**DEVELOPMENT CONSENT AUTHORITY
DARWIN DIVISION**

ADDENDUM

AGENDA ITEM: **3** **MEETING DATE:** 07/08/2026 **FILE:** PA2026/0196

APPLICATION PURPOSE: Hotel/motel (108 suites) in a 6 storey building

SHEET TITLE
SECTIONS K - M

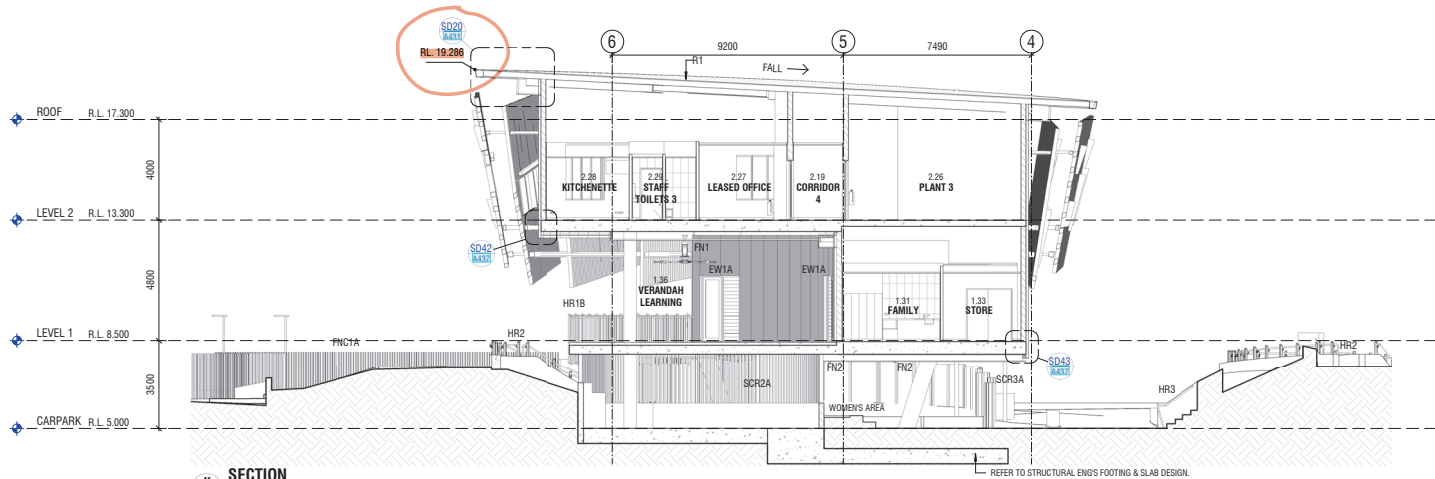
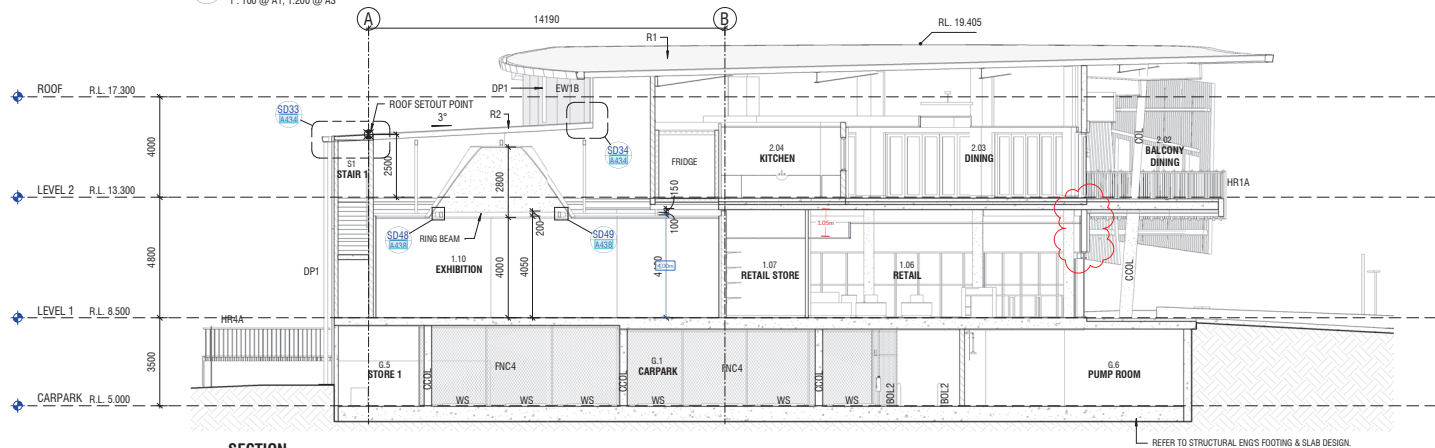
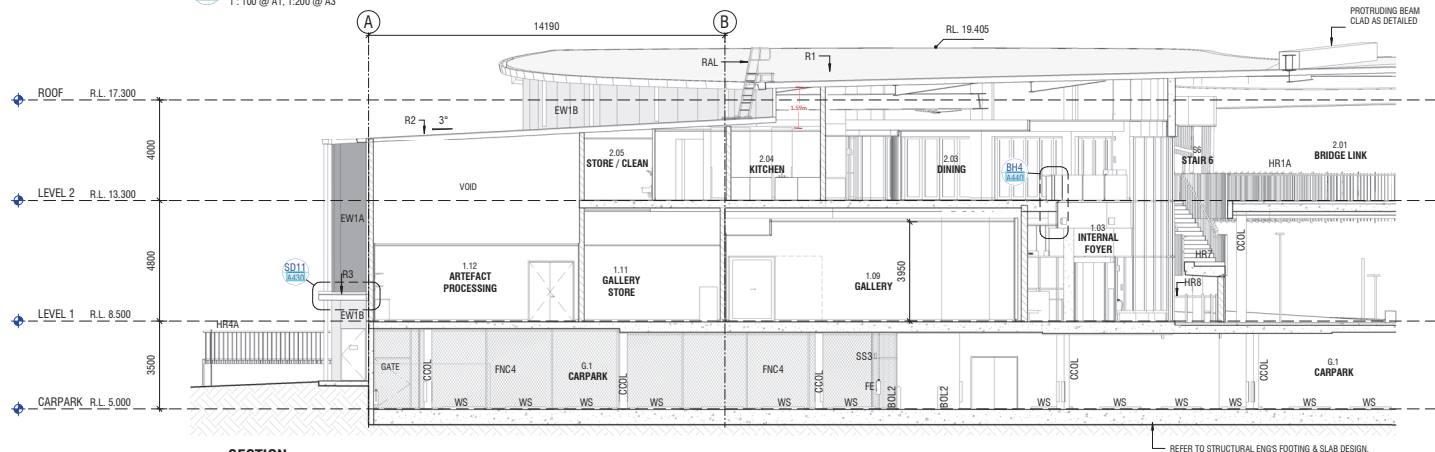
We are extremely surprised and disappointed that, notwithstanding clear and accurate Viewshed reports being provided to DAS by respondents before the slightly amended plans for application PA2026/0196 were distributed on July 17, that erroneous information appears to have been distributed to all respondents to the application. The proposed building exceeds the height of the Larrakia Cultural Centre as clearly shown in the respective architect drawings, the revised Application PA2026/0196, claiming otherwise. We can only ask why DAS issued this information knowing that the content was false and consider it very manipulative of the proponent to insist that you issue this document even with the inaccuracies being brought to their attention. We are attaching the accurate plans, previously provided to DAS as well as the proponents claim.

As a significant matter of concern relates to the height of the proposed hotel and hence its impact on a very significant Larrakia sacred site, the cultural significance of which is represented in the new Larrakia Cultural Centre, the insistence of issuing this false report demonstrates disregard by the proponents for Larrakia both as proposed

SECTION K - M

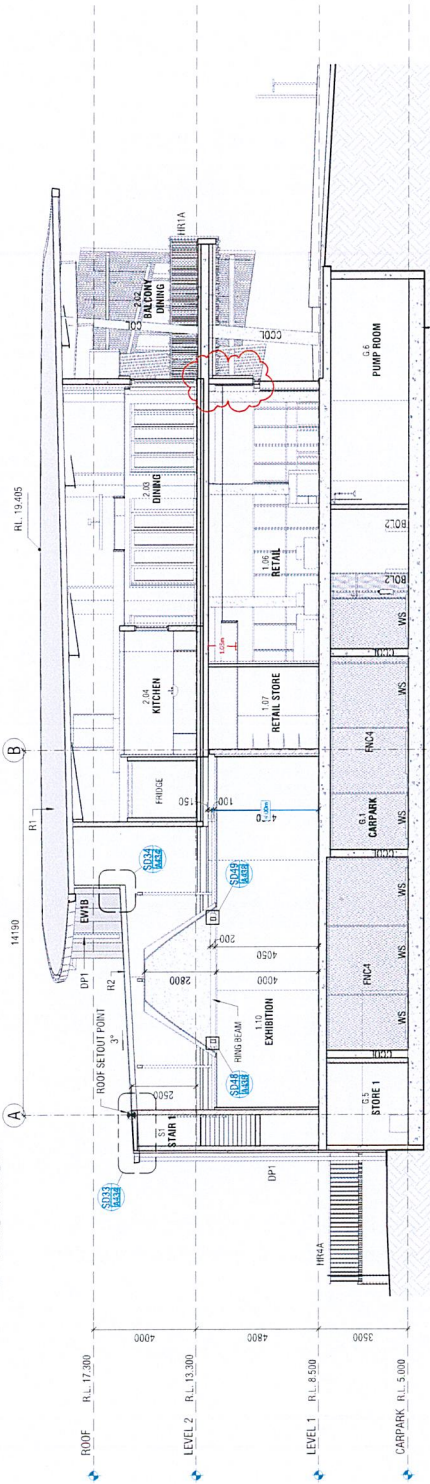
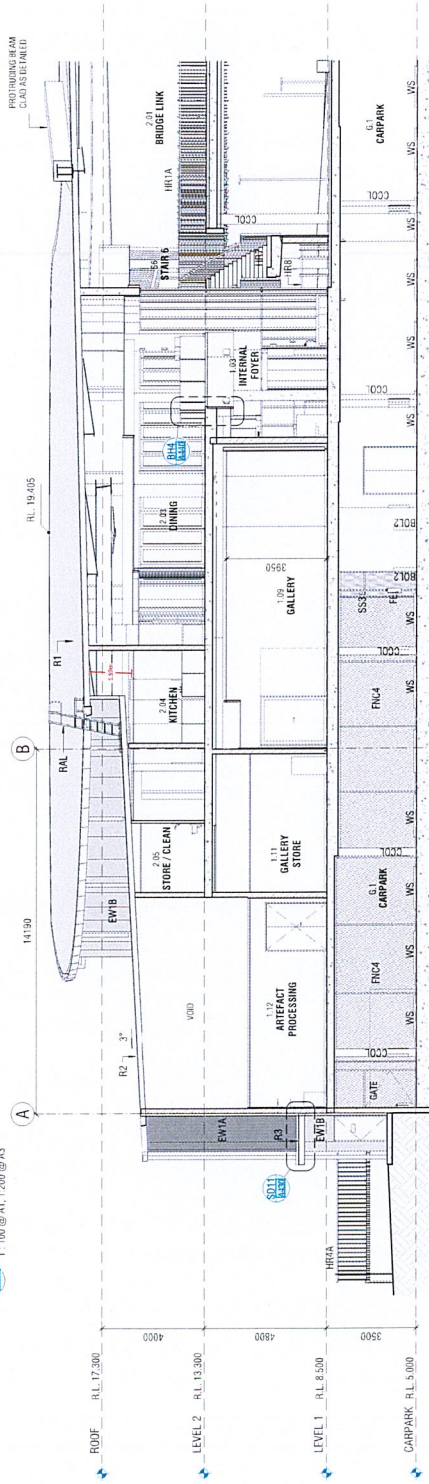
As already raised directly with the department and acknowledged, we are very concerned that despite our attempts to work with the Department to ensure correct documentation is available to responders, the Viewshed report which has gone out to all respondents to the application, still contains the original factually incorrect information. This is concerning to us, misleading to the public at large and extremely manipulative of the proponent to insist on still issuing this document even with the inaccuracies being brought to their attention. I attach the Viewshed Report clearly showing the inaccuracies.

As the matter of concern relates to the building height and impact on a Larrakia sacred site the insistence of issuing this false report demonstrates a staggering level of disregard for Larrakia as the traditional owners where the development is taking place and one of their key immediate neighbours.
